# **As-built Baseline Monitoring Report**

**Cedar Branch Restoration Site  
Monitoring Year 00  
DMS Contract 6598  
DMS Project Number 97009**

## MEMORANDUM

Subject: Cedar Branch Stream Restoration Site  
MY-00 Monitoring Report Comments  
Yadkin River Basin CU 03040103  
Randolph County, North Carolina  
NCDMS Project # 97009  
Contract # 006598

Longitudinal Profile  
Cedar Branch - T3-1  
Monitoring Year 00, 2018

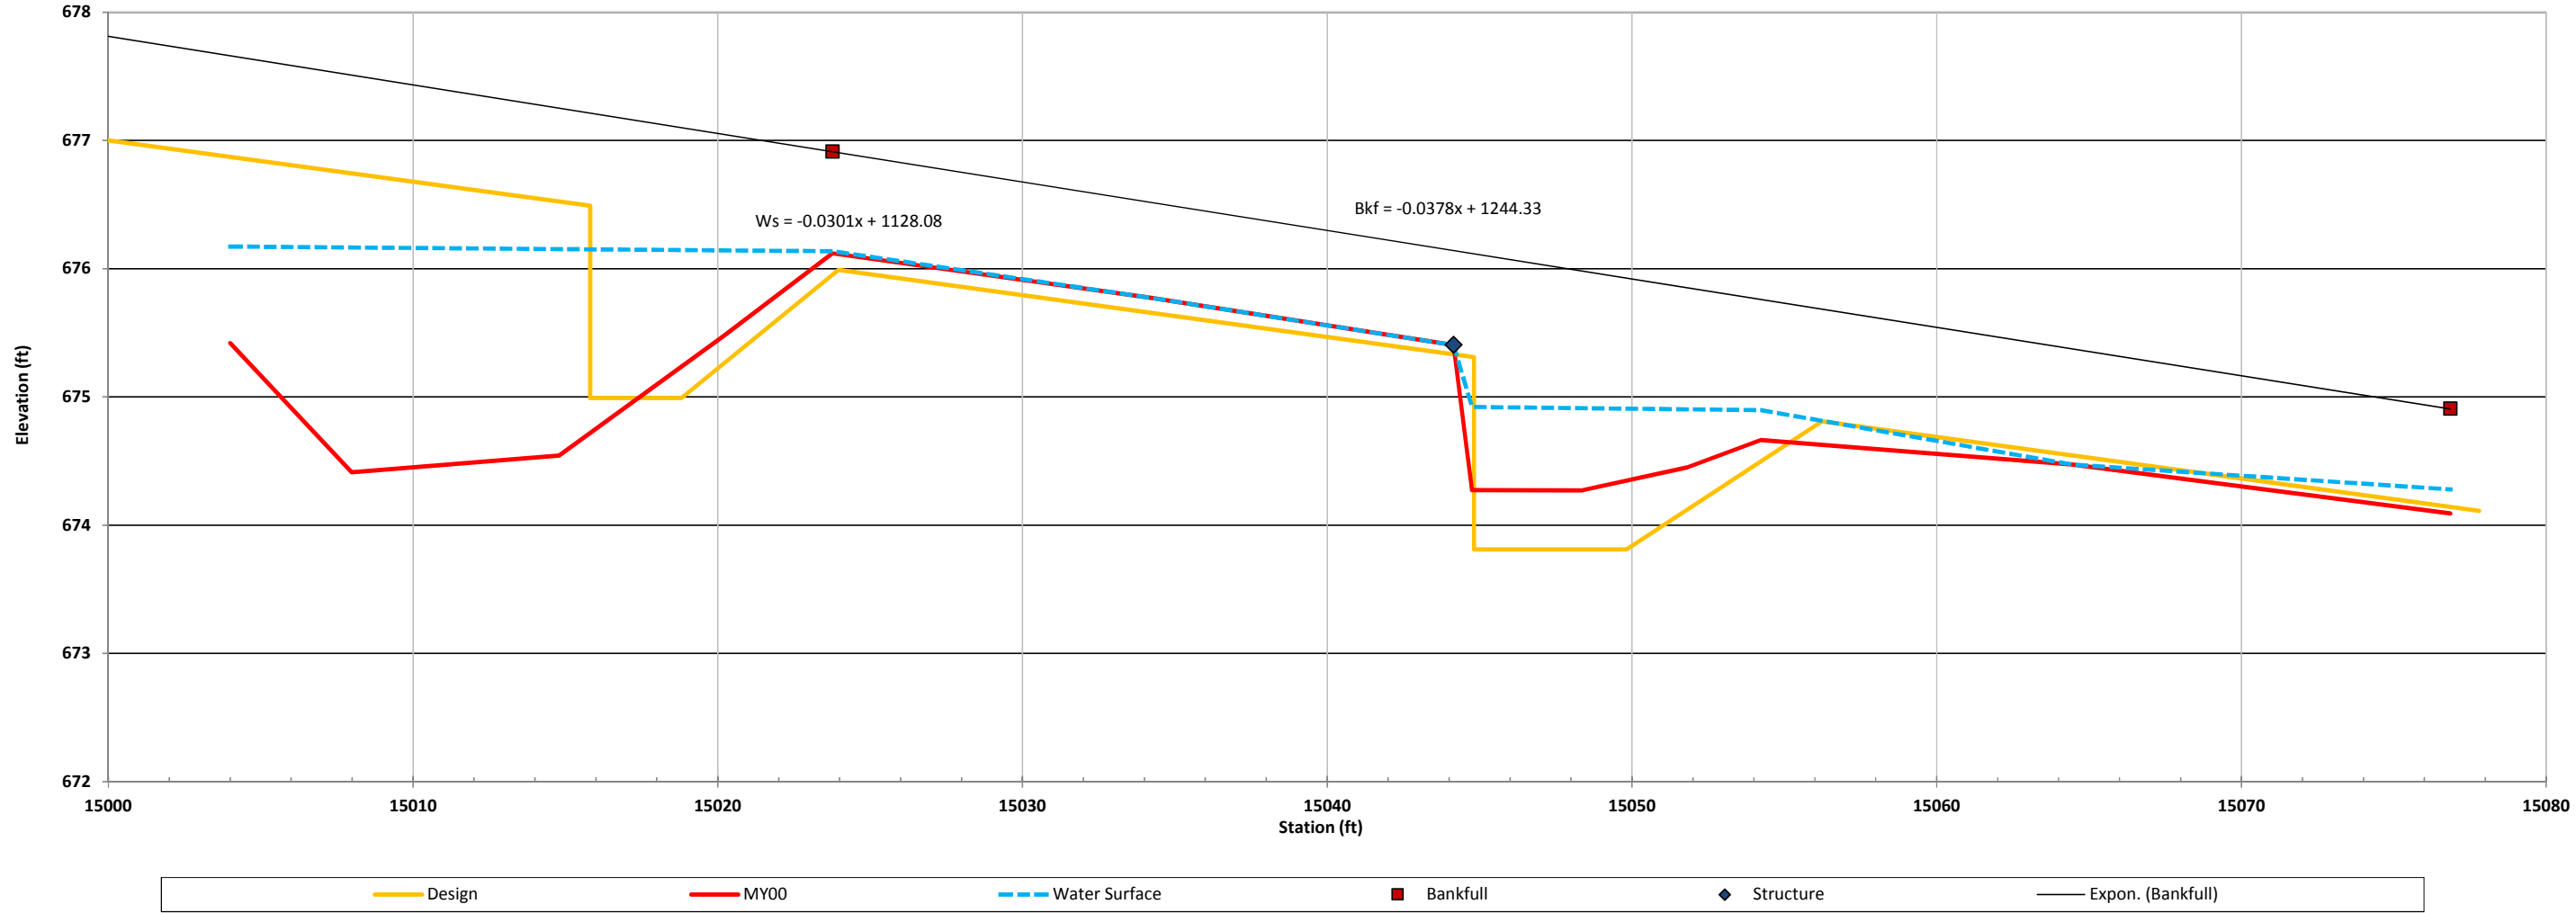
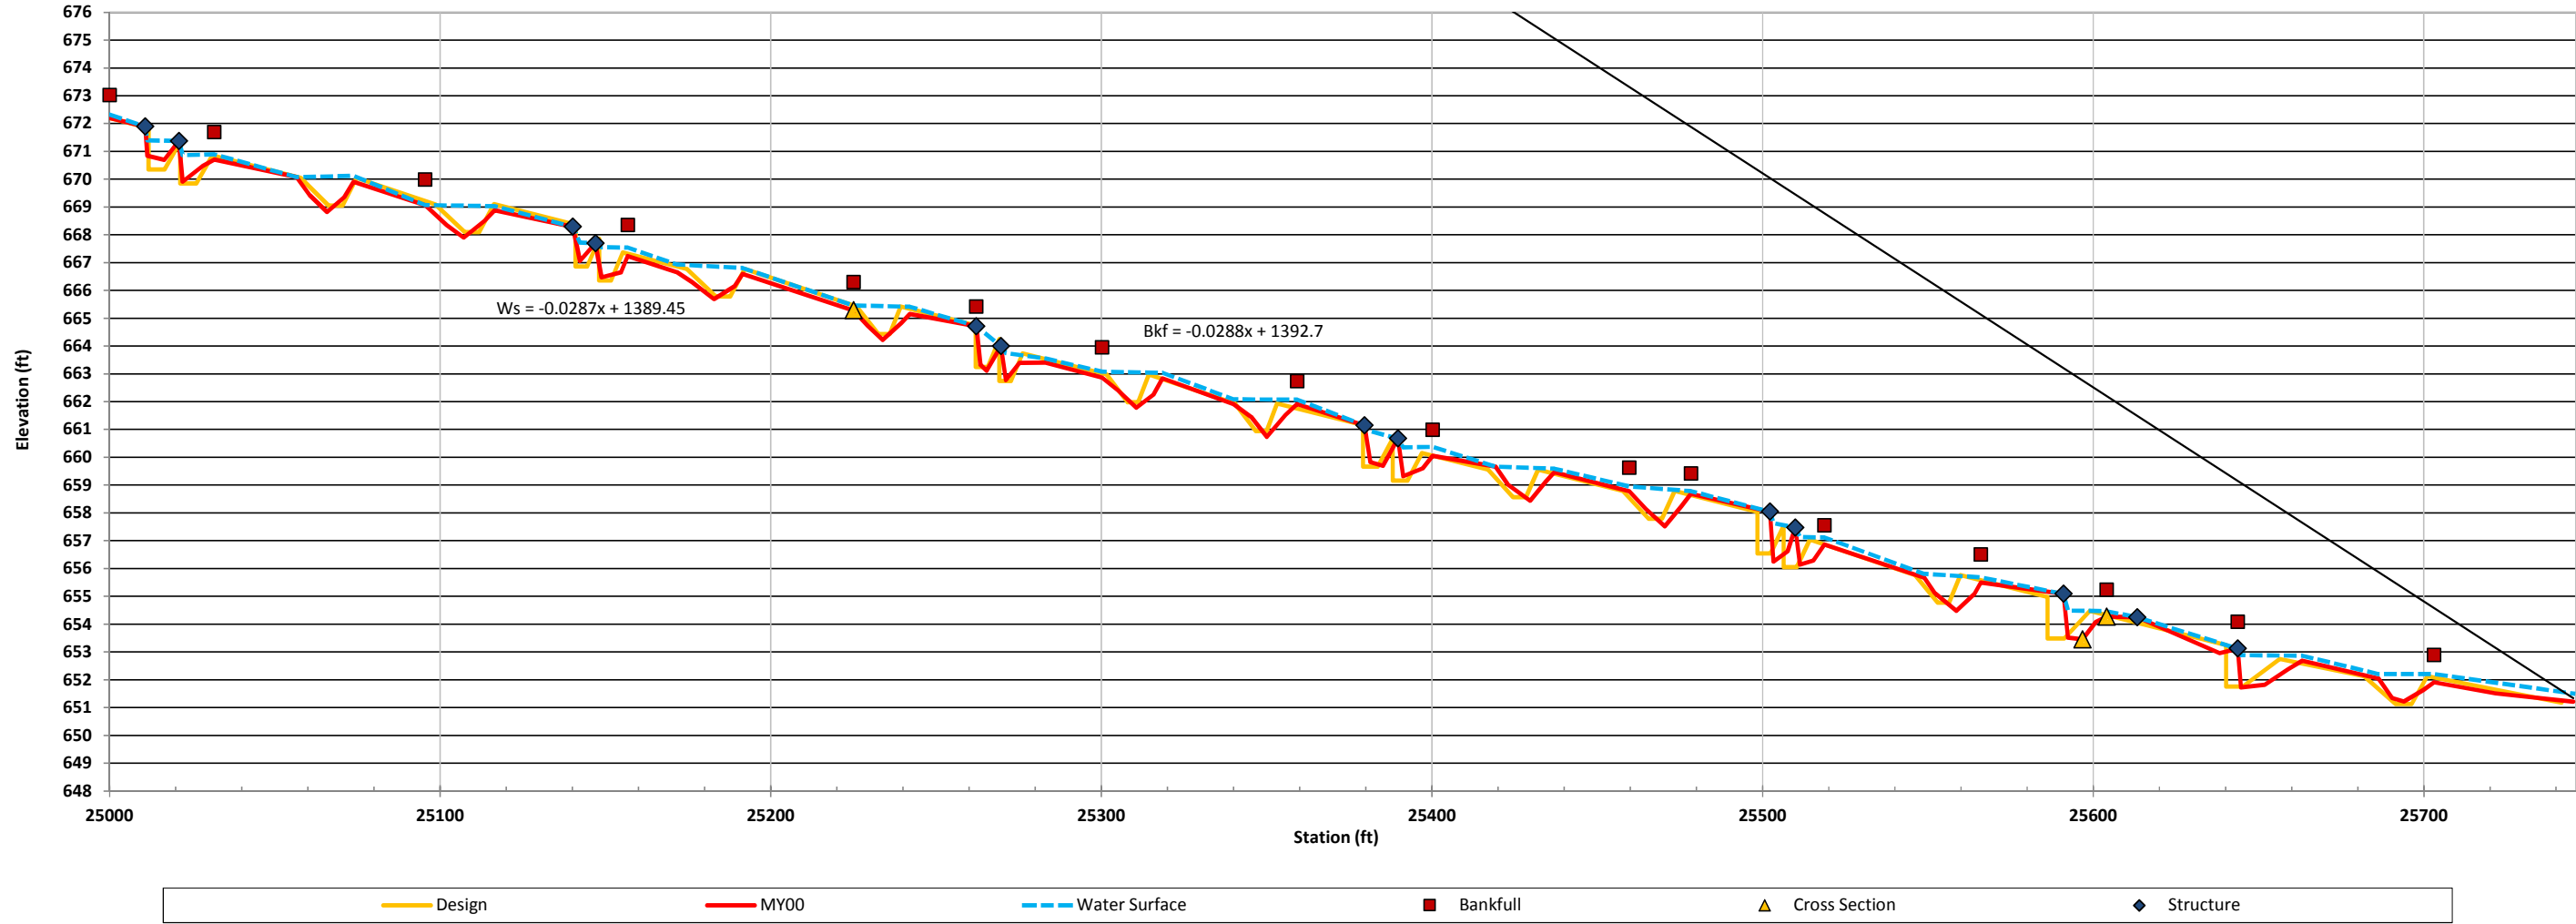
Please plot the design profile on the graph with the surveyed MY0 profile.

- *This has been added to the report.*

## Cross-Section Plots

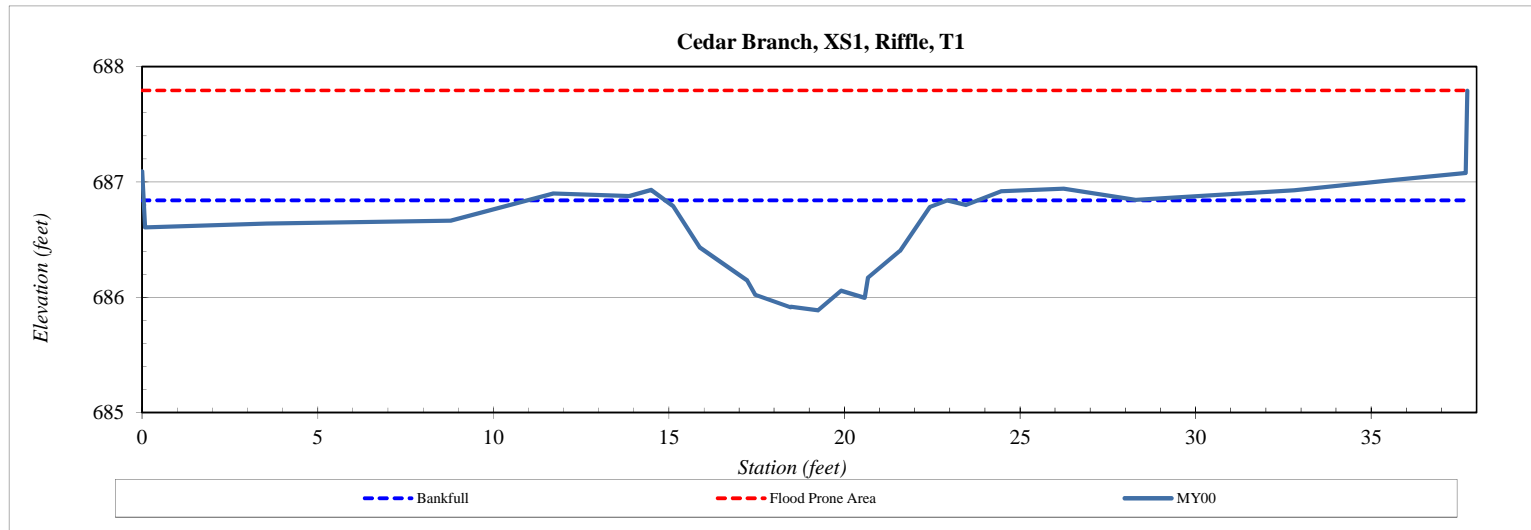
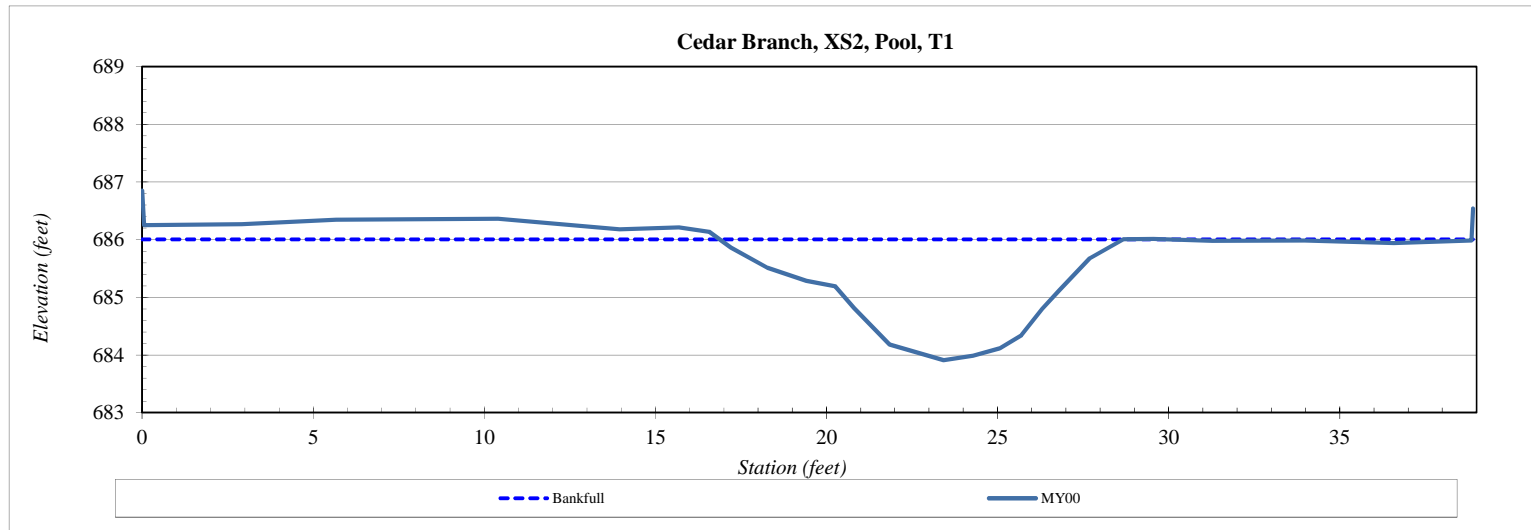
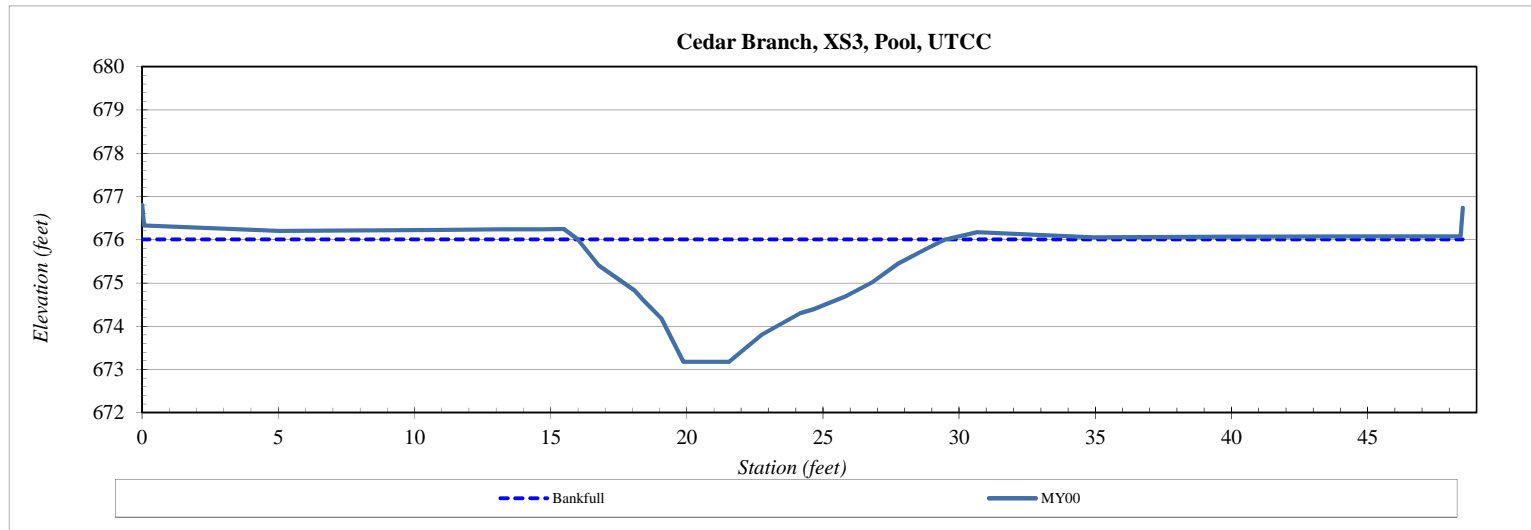
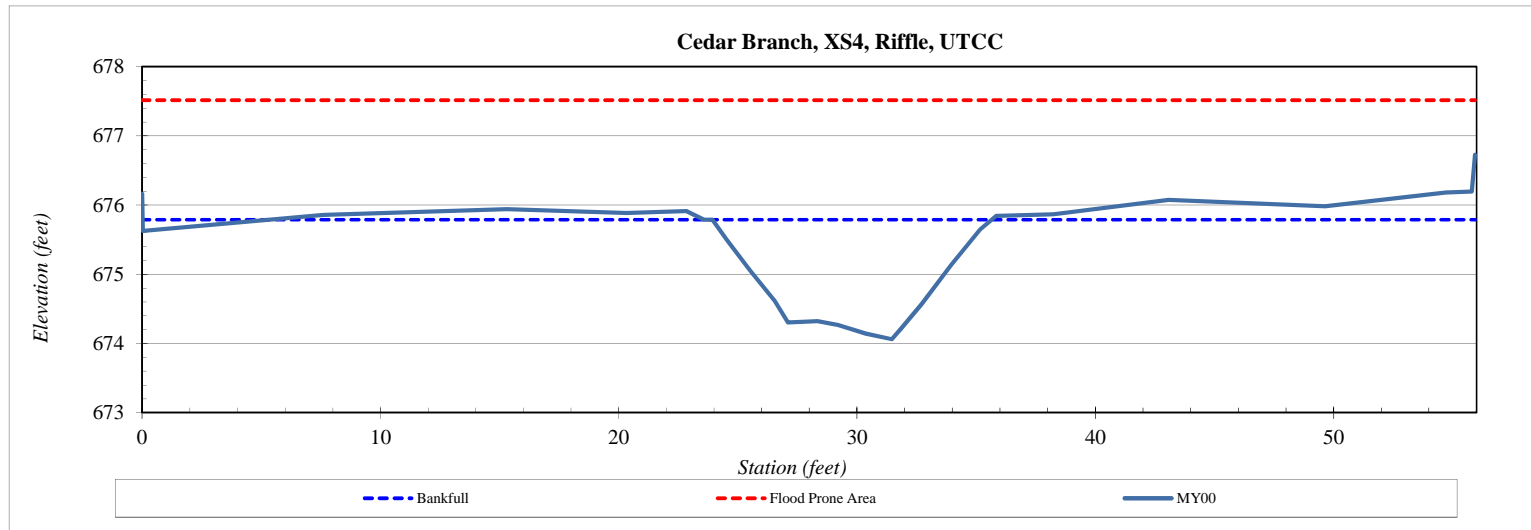
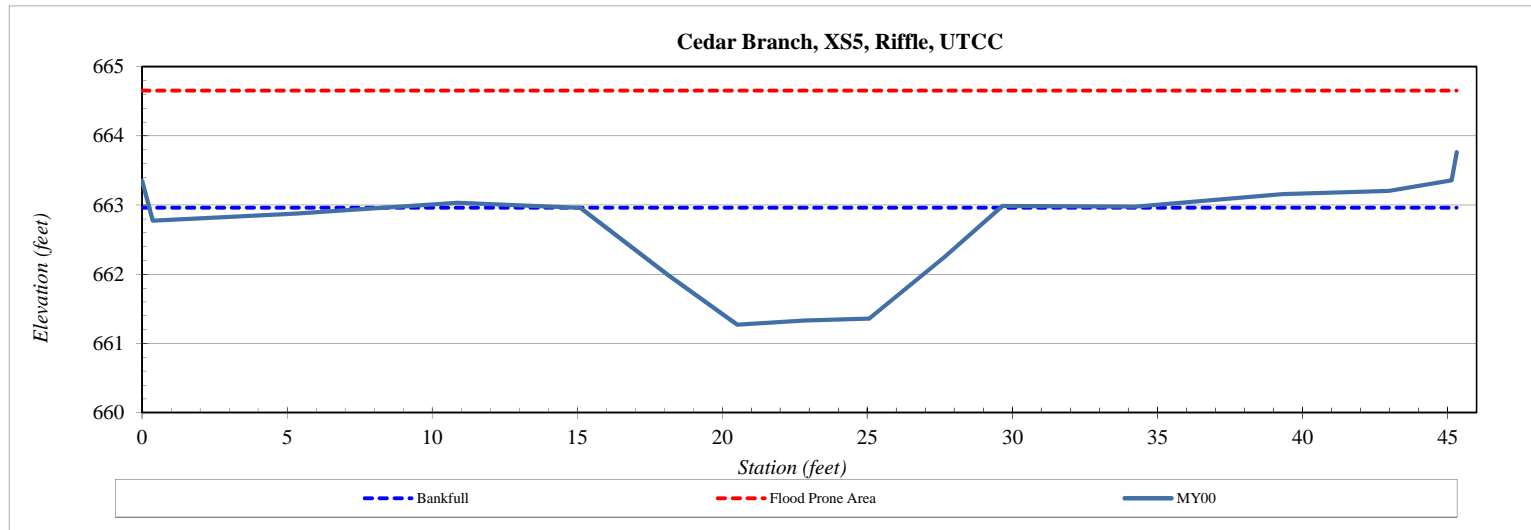
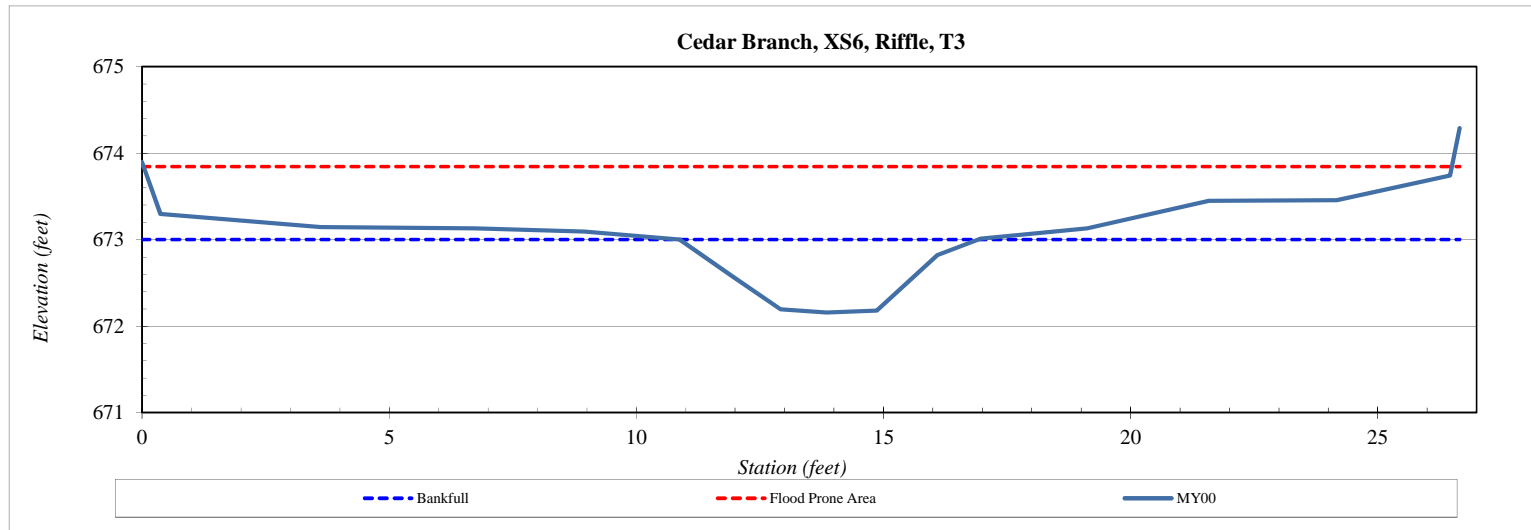
Cross sections need to be QA/QC. The majority of XS graphs do not match Summary Data. Multiple instances of bankfull elevation on graph do not correspond to numbers in Summary Data. Other numbers in Summary data are incorrect as a result. Elevation axis labels needs to be revised for several sections. I assume the intervals are in .5' increments, but the current axis shows multiples of the same whole number. Table 7 may need to be updated once this issue has been corrected. Please check all cross sections and revise.

- *All Summary Data has been reviewed and verified. The issue arose from the axis labels being rounded up from 0.5 to 1. This issue has been corrected, and because it was just an issue with the labels on the axis, did not require updates to other sections of the report.*
